Employment Land Road (DC/25/1543) Update

We are writing on behalf of Legal & General (Strategic Land North Horsham) Limited ('L&G') to clarify the outstanding matters in relation to the application for full planning permission for the Employment Land Road (LPA reference DC/25/1543).

This letter and submission seeks to provide responses/ clarifications to the ecology and arboricultural follow-up comments We have also sought to provide an update in respect of Biodiversity Net Gain ('BNG') to provide context to the further amended landscape scheme and updated BNG Metric.

Figure 1: Proposed bank on northern side of Employment Road.

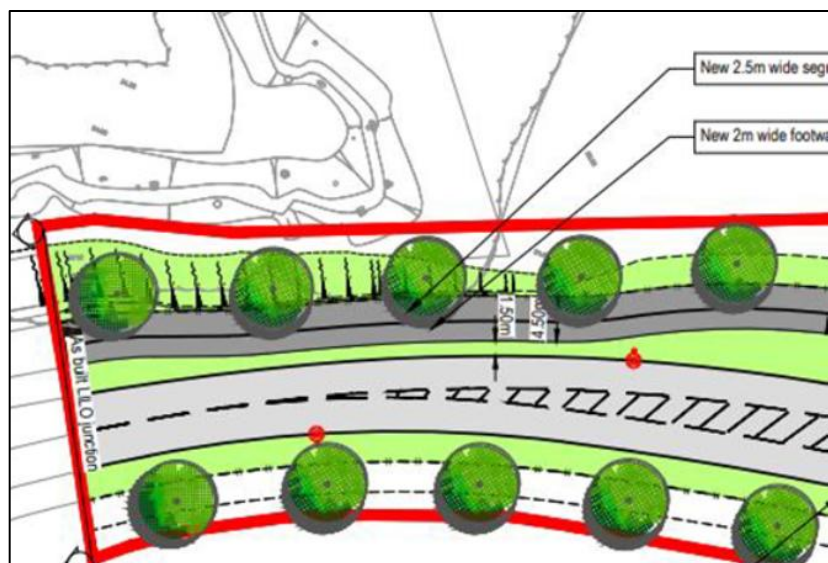
'At para 7 of the response, landscapes highlight concerns with land level changes connected to the road /footway; there are a few good mature trees in this area that could be impacted by the change in land levels. It would be preferable to seek an engineering solution to address this such as retaining wall, or something similar to limit the impact on the RPAs of the affected trees.'

The question asked is whether it would be appropriate to have a retaining wall (or something similar) along the northern side of the road where land levels change instead of the re-grading of soil in this area to create a slight incline as per the current proposals.

The proposed embankment is a natural-looking landscape feature which has been designed to be self-supporting. Increasing the slope or building a retaining wall in this area would create significantly greater ground disturbance and change the natural looking edge of the woodland group. The Applicant's highways consultants are also concerned that a retaining wall could create a safety hazard for road users that would need to be addressed.

Considering the above, we suggest, with regards to the arboricultural impact of the development, to retain the proposed ground levels as per the proposed plans.

Figure 3: Areas of Encroachment

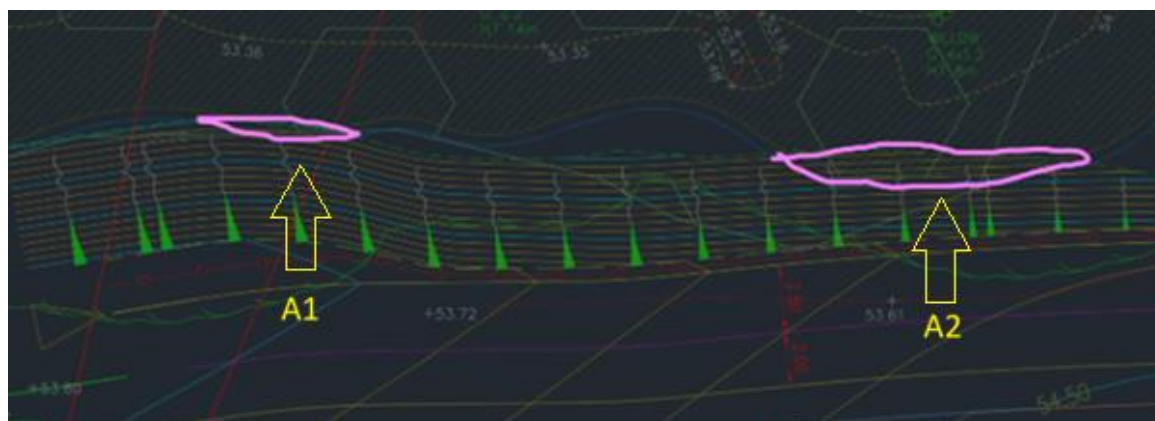
The area of required soil level changes will encroach marginally into the group in two specific areas of G45-PA which have been annotated onto the plan below. In both areas existing Blackthorn scrub and suckering growth will be cut back.

A1 (west) requires a very minor re-grading of the soil levels over 2.5m² into G45-PA with a maximum of 200mm of soil displacement. This very minor encroachment would be approximately 5m from the base of a single stem Alder which is dead or in advanced decline (see Figure 4).

The area proposed for re-grading is therefore likely to be outside of the RPA of the tree. Furthermore, as the Alder is a poor-quality specimen in declining health, alternative engineered options are not justified on this occasion.

Based on this assessment, the proposed re-grading of two areas within G45-PA will only necessitate the removal of dense blackthorn scrub / suckering growth and will have no detrimental impact to the health or stability of any individual specimen tree. The loss of Blackthorn at the edge of the wooded area will not detract from the amenity of the wider woodland group as a whole.

Figure 5: Distance between Goat Willow and edge of re-graded incline

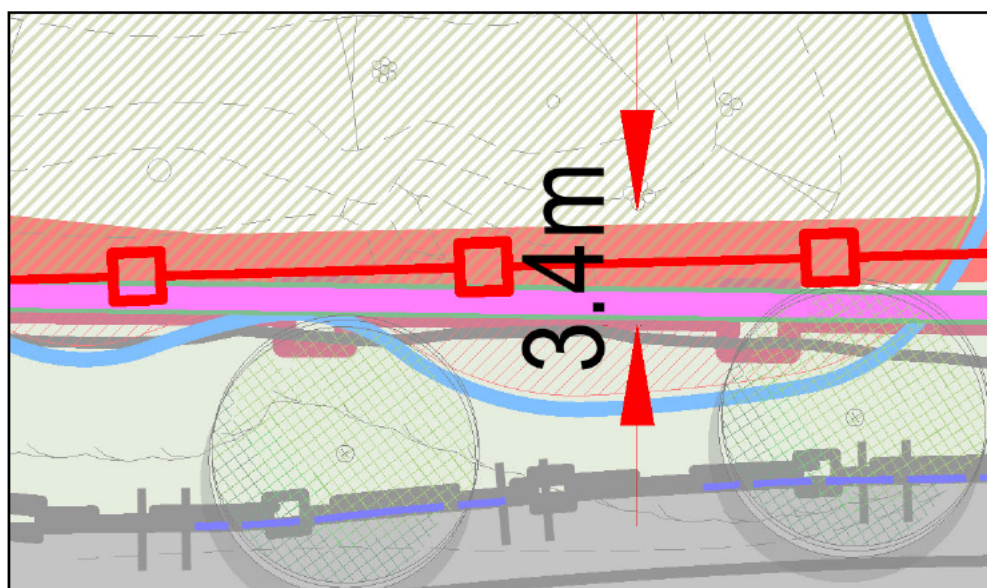
With regards to 'A2', the eastern area of soil re-grading is 3.4m from the base of a multi-stem Goat Willow. Whilst this tree was not detailed specifically in the BS:5837 survey, the topographical survey recorded a multi-stem tree, 8m tall and with four stem 120mm diameter. Under BS:5837 (2012) the tree therefore requires a Root Protection Area radius of 2.9m (area of 26.1m²).

Based on this information, the Applicant's Arboricultural Consultant is satisfied that the proposed re-grading of soil in A2, being 3.4m from the tree, is outside of the root protection area of the Goat willow and will have no significant impact on tree health or stability.
